# Some Comments on Assembly and Performance of pre-series RE2/2 chambers

With input and comments from all colleagues in the ISR lab.  
Additional corrections and tuning by Austin Ball

The 3 Chambers were received at CERN on the 2nd June 2005.

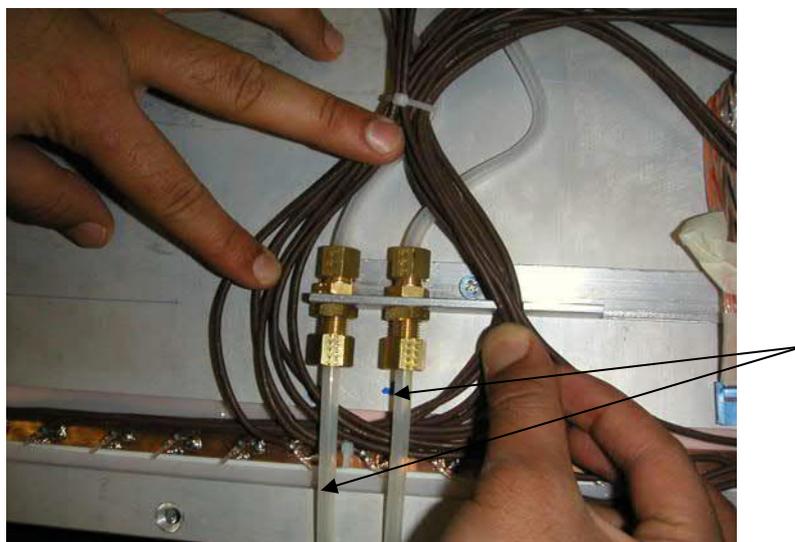
A similar argument can apply to the other side. Note the external gas pipes.

All unions and their respective lock nuts must be tight, otherwise twisted gas pipes and leaks can result.

- Shield Cover

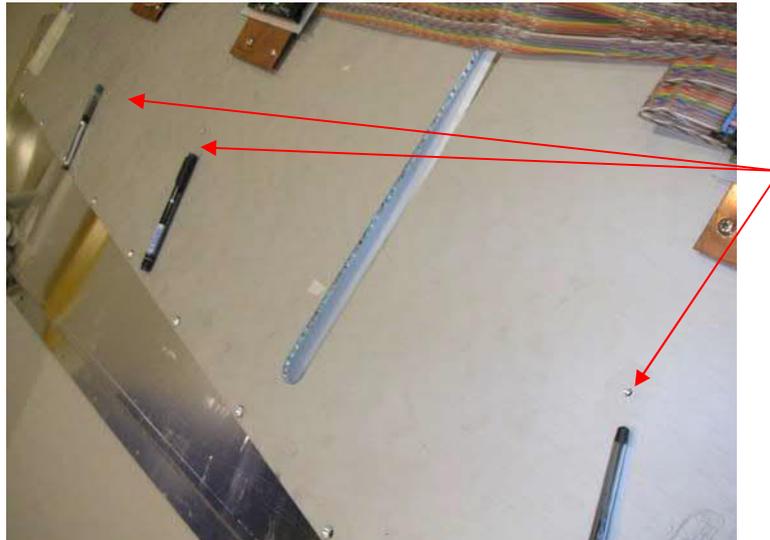
The shield cover had been intended to be mounted on the 6 x M5 threaded inserts indicated in the photo below. The use of a full span shield cover has some advantages, such as immediate full access, but will inevitably increase the occupation in 'Z' due to the flexibility of itself. Primarily, however, the access to the electronics/chamber of the on yoke chambers requires the 2 adjacent chambers to be removed beforehand. This mistake has been made by the CSCs, we should not limit our access, especially since the decision to have the CSCs on one yoke and the RPCs on the opposite was made in part for this reason

Note the 3 pens indicating the positions of the mounting inserts.

The shield cover was designed to be attached at six points along 'R' each side of the FEB's. Taking the cover to the outside edges increase the occupation in 'Z'. The cover is 25 mm deep and should be decreased to ~20mm as is achieved in RE1/2. & 3. The total chamber thickness is between 56.4 and 55.4mm.

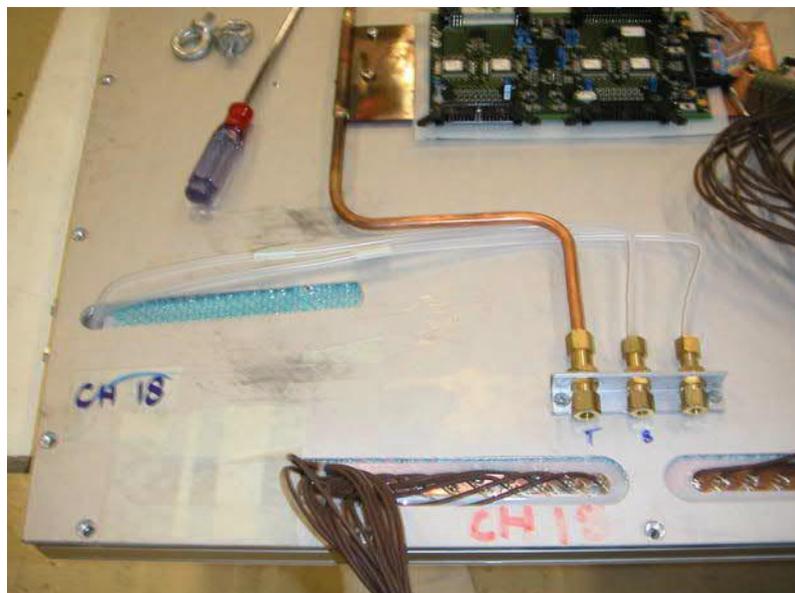
Given the proximity of the CSC alignment sensor at 94.5mm and the fact that these two elements (RPC and CSC alignment) are mounted on different yokes each of many hundreds of tons, some 7mm has to come off the total/final assembly in 'Z'. The aim is to be less than 90mm.

- Packaging

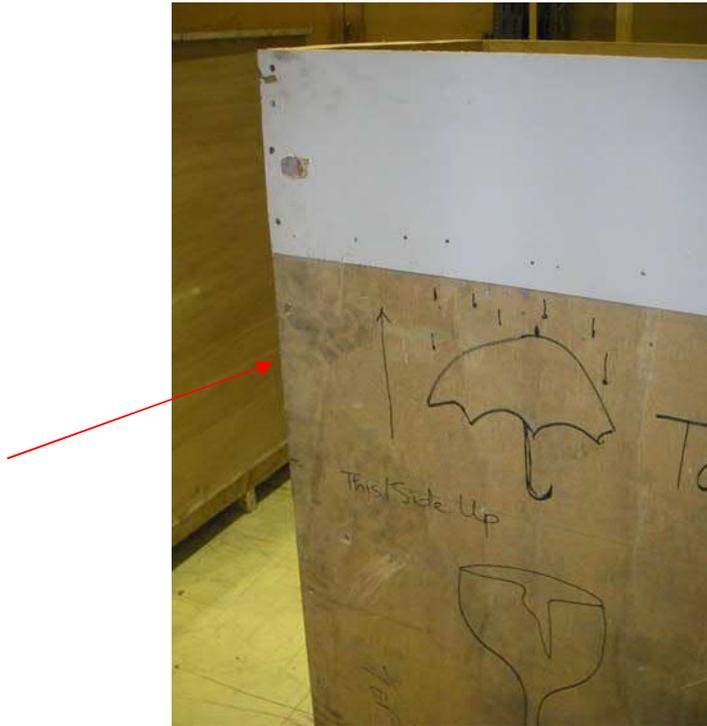
The ever present problem of damage that may occur during transport has occurred yet again. Note the 'heavy' foot prints on only one side of the now upright box, indicating that the box, and its contents, spent at least some time horizontal. With packing for more chambers this will be less likely to occur as the base of the box will increase in width so imparting greater stability and thus a lesser likelihood of tilting over. The box naturally ended up in its most stable condition that is with its largest surface on the ground!

'This side up' could be interpreted as meaning the side it is written on not where the arrow points.

The steel frame is a good feature which provides rugged support for the chambers and in particular the space left around the structure gives some protection against fork lift perforation. This space could well be increased to >10cm.
